Project	IEEE 802.16 Broadband Wireless Access Working Group < http://ieee802.org/16 >	
Title	Remedy of double EAP mode	
Date Submitted	2005-07-21	
Source(s)	Junhyuk Song, Jicheol Lee, Alper Yegin Samsung Electronics Yoshihiro Ohba Toshiba	junhyuk.song@samsung.com jicheol.lee@samsung.com alper.yegin@samsung.com yohba@tari.toshiba.com
Re:	IEEE P802.16e/D9	
Abstract	<p>Remedy of double EAP mode Authentication</p> <p>Double EAP mechanism is proposed in order to use an EAP method instead of RSA for device authentication. EAP framework enables use of various EAP methods and device credentials (including pre-shared secret based ones), instead of always using X.509/RSA.</p>	
Purpose	Adopt this contribution as a remedy of double EAP mode	
Notice	This document has been prepared to assist IEEE 802.16. It is offered as a basis for discussion and is not binding on the contributing individual(s) or organization(s). The material in this document is subject to change in form and content after further study. The contributor(s) reserve(s) the right to add, amend or withdraw material contained herein.

Remedy of EAP-in-EAP mode

Junhyuk Song, Jicheol Lee, Alper Yegin (Samsung Electronics)
Yoshihiro O

**Figure 133a- AK with PMK and PMK2
(EAP-based authorization and Authenticated EAP-based authorization)**

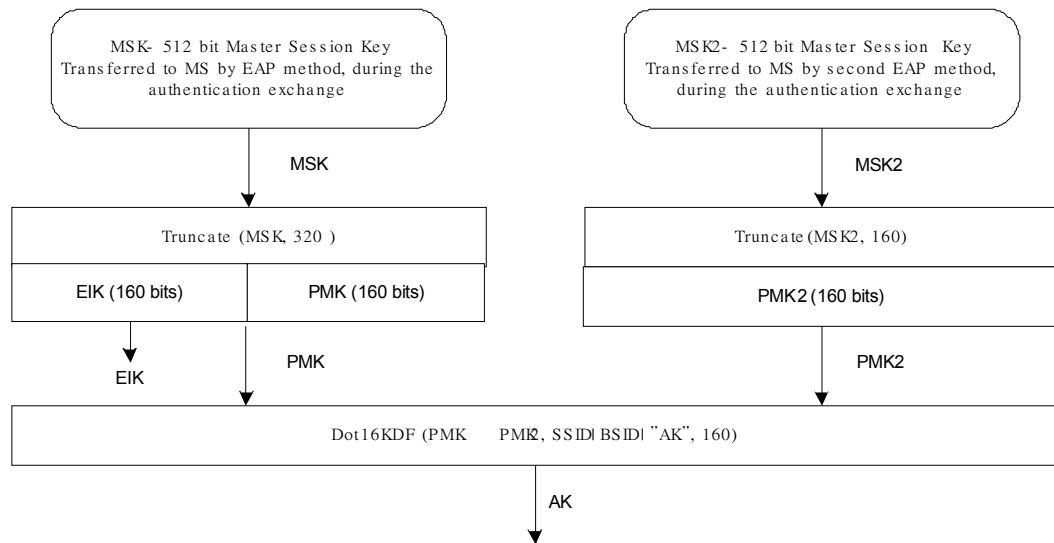
[Add following figure and text right after figure 133 in page 216 of 802.16e/D9]

Figure 133a outlines the process to calculate the AK when EAP in EAP mode authentication exchange has taken place, first EAP yielding EIK and MSK and second EAP yielding MSK2.
